TECHNCIAL NOTE no.: 33	
Product:	GPS antenna position
Part number:	s/r
To:	Audi RS3 LMS Gen2 and Cupra Leon Competicion
Date:	04/05/2022

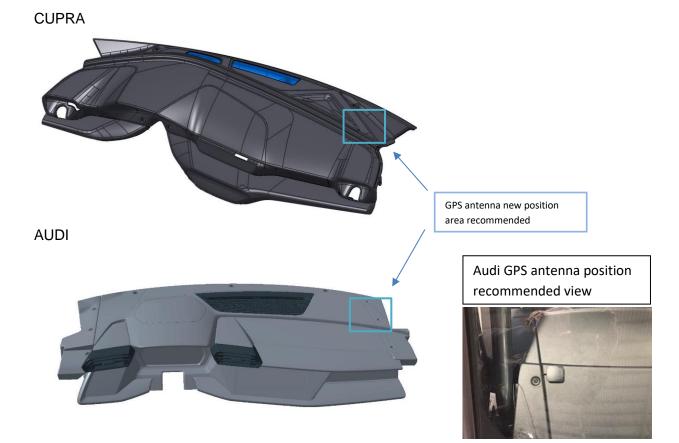
A lack of GPS signal in circuits with high vegetation has been reported.

Cars manufactured before 2022 have the GPS antenna positioned underneath of the dashboard (*position in the middle of the cockpit fixed by magnet*).

Is recommended to change the antenna position to over the dashboard or if needed on the exterior of the car

To fix it over the dashboard (plastic) you can use 3M double sided tape.

## ECUMASTER GPS SW UPDATE

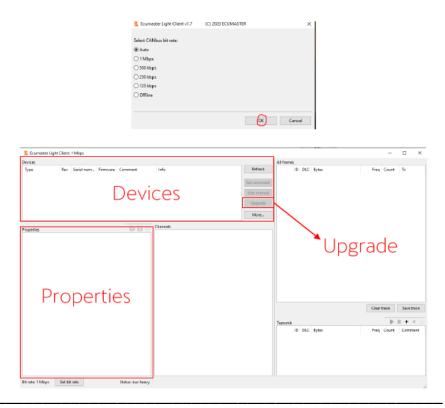
TO REMEMBER: The GPS module bought directly from ECUMASTER dealers could not be updated with the right Software. In this case, use the Software LightClientSetup\_1\_7.exe and gps\_15\_0.bin file to update the GPS module.

- 1. Install LightClientSeraup\_1\_7.exe in your computer
- 2. Connect the display CAN interface to the diagnostic connector and switch Power supply
- 3. Open the LightClient application and choose "auto" as CAN bit rate
- 4. In the device zone, choose the GPS module. Double click on it.
- 5. Click on the Upgrade and select the file "gps\_15\_0.bin"
- 6. Wait until then firmware update is done.
- 7. In the properties zones, satellites, select just GPS. Not GPS + GLONASS
- 8. Disconnect the computer and power cycle the car.
